# Abnormal Chirp or Squeak Noise From High Pressure Fuel Pump

YEAR(S)	MODEL(S)	ADDITIONAL INFORMATION
2013 - 2016	FR-S

**Figure 1.**

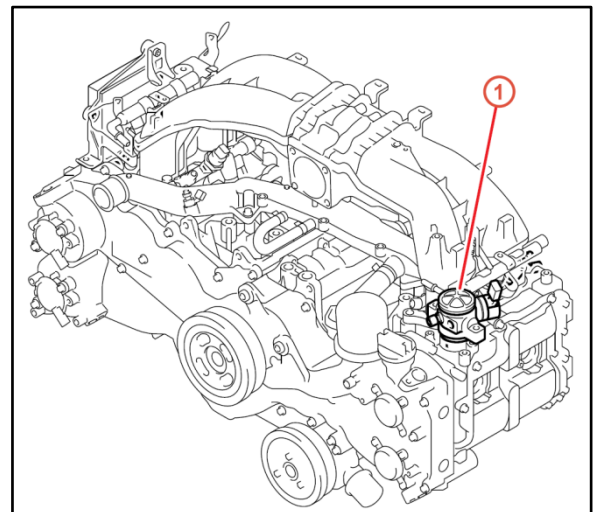
Some 2013 – 2016 model year FR-S vehicles may exhibit a high pitch chirp or squeak noise from the high pressure Fuel Pump Assembly when the engine is fully warmed-up and idling. Follow the procedure in this bulletin to address this condition.

1. Road test the vehicle for at least 10 minutes so that the engine is fully warmed-up.
2. While the engine is idling, listen for abnormal noise from the high pressure Fuel Pump Assembly.

- A mechanical ticking noise from the high pressure Fuel Pump Assembly is normal during direct injection system operation.
- This bulletin should **ONLY** be performed if an abnormal high pitch chirp or squeak noise from the high pressure Fuel Pump is verified.

- **YES** — Continue to step 4.
  - **NO** — This bulletin does NOT apply. Continue diagnosis using the applicable Repair Manual.
4. Replace the high pressure Fuel Pump Assembly.  
Refer to the to the Technical Information System (TIS), applicable model and model year Repair Manual:
    - 2013 FR-S:  
*Engine/Hybrid System – Fuel System – “FA20 Fuel: Fuel Pump (for High Pressure): [Removal / Installation](#)”*
    - 2014 FR-S:  
*Engine/Hybrid System – Fuel System – “FA20 Fuel: Fuel Pump (for High Pressure): [Removal / Installation](#)”*
    - 2015 FR-S:  
*Engine/Hybrid System – Fuel System – “FA20 Fuel: Fuel Pump (for High Pressure): [Removal / Installation](#)”*
    - 2016 FR-S:  
*Engine/Hybrid System – Fuel System – “FA20 Fuel: Fuel Pump (for High Pressure): [Removal / Installation](#)”*
  5. Confirm repair.
